Board of Zoning and Planning

Staff Report - January 28, 2021

Application No.: BZAP-20-63

Address: 424 S. Columbia Ave.

West (Front)

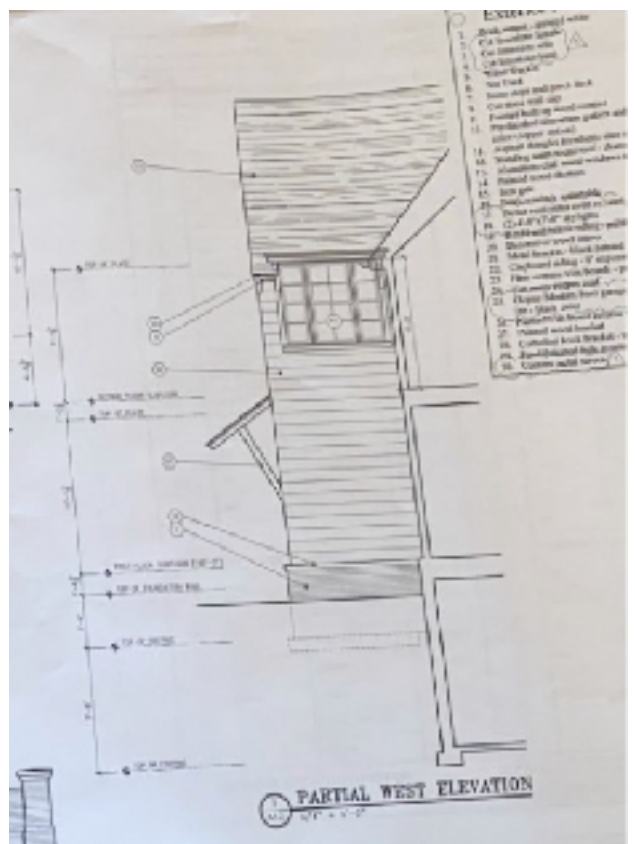
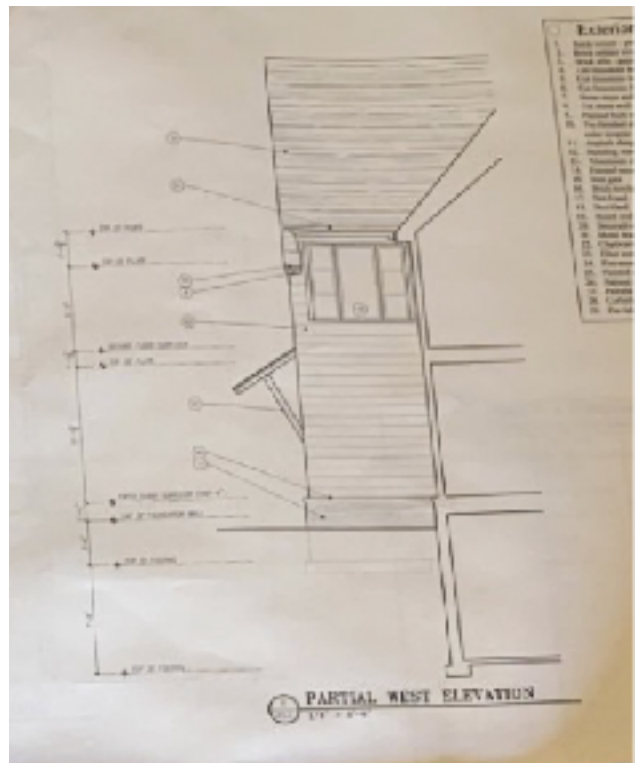
- Ridge height changed from 36' 6" to 39' 3" (max allowable is 40')
- Window grid pattern

South Elevation:

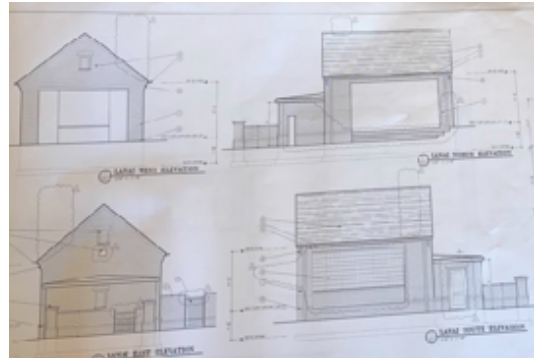
- Ridge height changed
- Window grid patterns, sizes and placement changed
- Brick lintels used instead of limestone - will be changed to limestone in accordance with original design.
- Skylights added
- Relocation of stone wall behind Lanai

Plans:

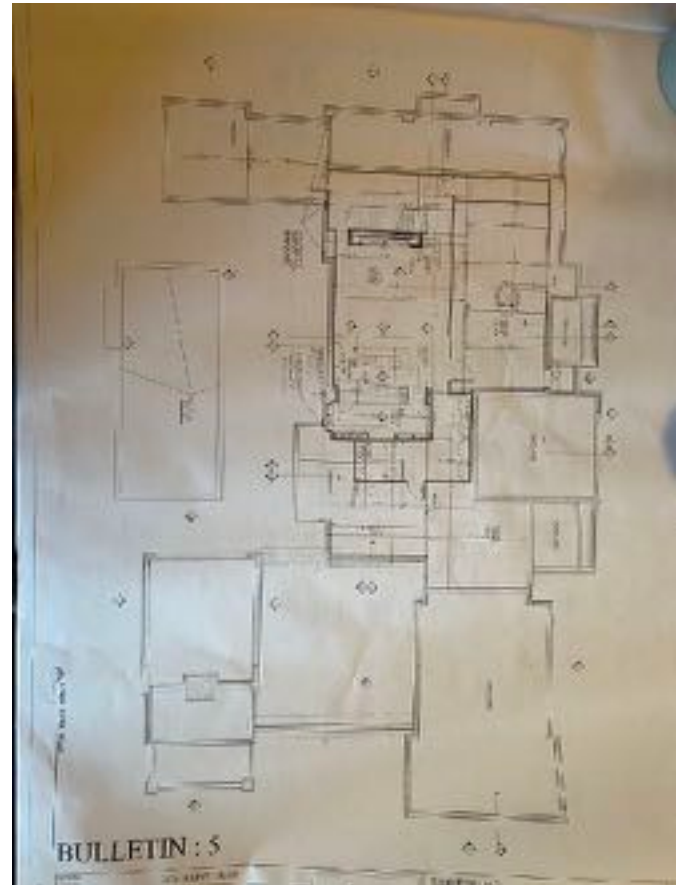
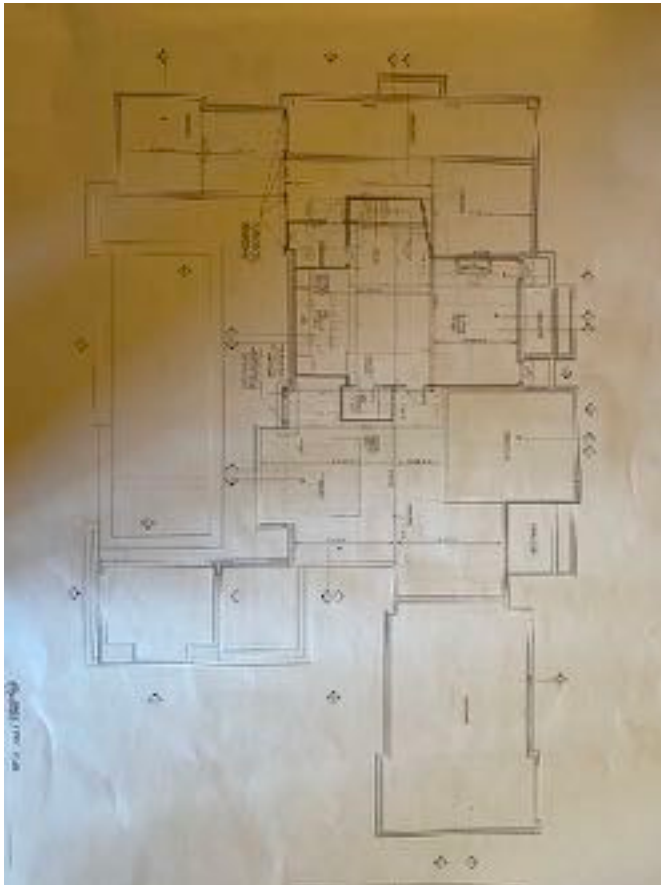
- Ridge direction of poolhouse changed and footprint increased in size due to storage and pool equipment area.
- Circular drive was not approved.
- Gate, wall and fence changes
- Increase in pool size and pool house
